STAFF REPORT

CITY OF COLUMBUS PLAN COMMISSION (March 12, 2014 Meeting)

Docket No. / Project Title: PUDF-14-04 (Columbus Crossing Lot 1B)
Staff: Allie Keen
Applicant: MAP Columbus Crossing, LLC
Property Size: 3.05 Acres
Current Zoning: PUD (Planned Unit Development)
Location: 2035-2145 W. Jonathon Moore Pike, in the City of Columbus

LOT 1B - PARKING LOT IMPROVEMENTS
 2085 W. JONATHAN MOORE PIKE
 COLUMBUS, INDIANA 47201
SITE PLAN
 PROJECT NUMBER
MAP.006
 DRAWING NUMBER
C2.0
 SHEET 2 OF 6

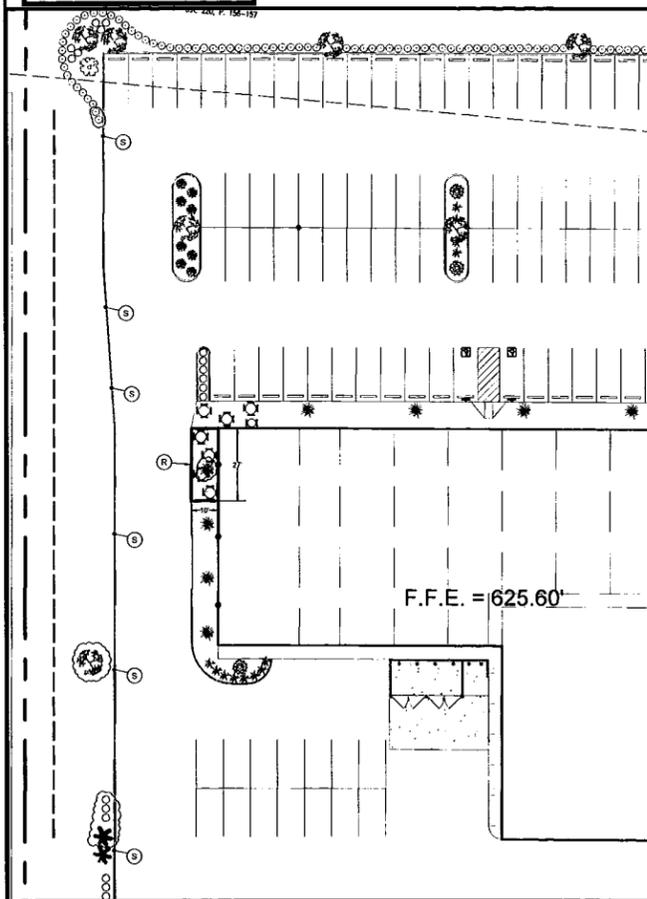
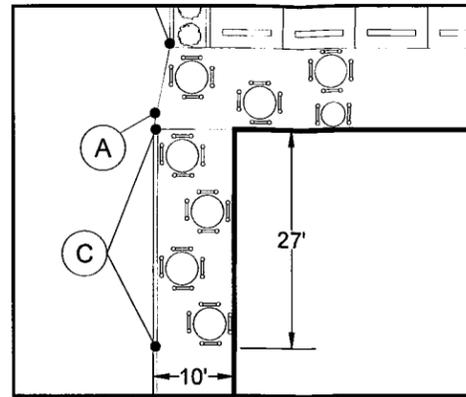
3. The curbing to be provided at the southwest corner of the parking lot shall be clarified to ensure that the landscape area at that location is adequately protected from vehicles (consistent with Zoning Ordinance Section 7.2 (Part 4)(A)(5)(b)).

4. The cherry tree to be removed for the outdoor seating area shall be replaced elsewhere on the property as part of the construction project, with the site plan being revised to indicate the new location.

4. When the original Final PUD site plan for this property was approved, there was a landscape plan included and approved by the Plan Commission for the entire site. To accommodate the new parking spaces and outdoor seating, approximately 17 shrubs and 3 trees will be removed. The applicant has indicated on the provided site plan that the landscaping will be relocated on the site. However, there is one cherry tree planted on the west side of the building that will be removed for the outdoor seating area that is not shown as being relocated on the site plan.
